Mandatory Service Bulletin

M.S.B. No.: 05-8

Title: REPLACEMENT OF CLASSIC CAST CYLINDERS IN COMPLIANCE WITH AIRWORTHINESS DIRECTIVE 2006-12-07

Revision: 3 (02/26/07)

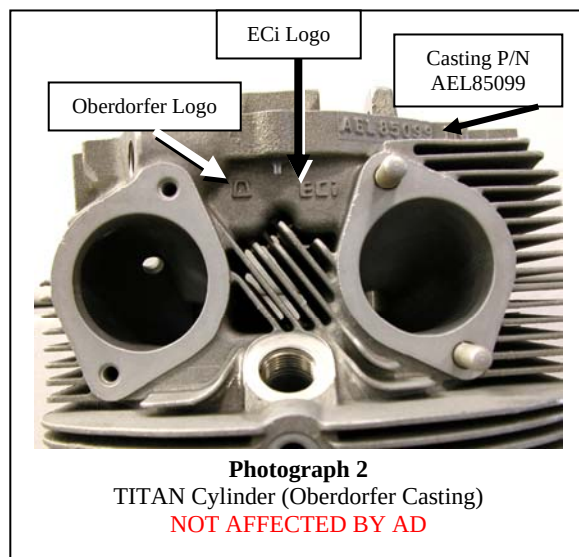
- 5.0 CYLINDER IDENTIFICATION:** The ECi Classic Cast cylinders that are affected by this AD are identified through several unique features. The primary identification feature is the casting part number, **65099-REV-1**, which is cast into the cylinder rocker flange above the exhaust port as shown in Photograph 1 (next page.) Classic Cast replacement cylinders for Lycoming parallel valve engines have this unique number while the TITAN® brand cylinders, which are **NOT** the subject of this Mandatory Service Bulletin, have casting number AEL**8**5099 (See photograph 2 next page.)

The “EC” logo on the Classic Cast heads is also on the rocker flange toward the intake port side of the cylinder head (Photograph 1), whereas the TITAN cylinder has the Oberdorfer logo as well as the ECi logo, instead of just “ECi” (Photograph 2.)

The cylinder serial number is marked on the side of the cylinder below the rocker cover flange on the intake side. Cylinders with part number 65099-REV-1 as described in Photograph 1 (above) **AND** with serial numbers that are between 110 and 9879 (and may have prefix “L” if cylinder spark plug boss is long reach) are affected by this service bulletin and AD 2006-12-07. Photograph 3 (below) describes the location of the serial number which must be 9879 or lower. **Cylinders with serial numbers 9880 or higher are not affected.**
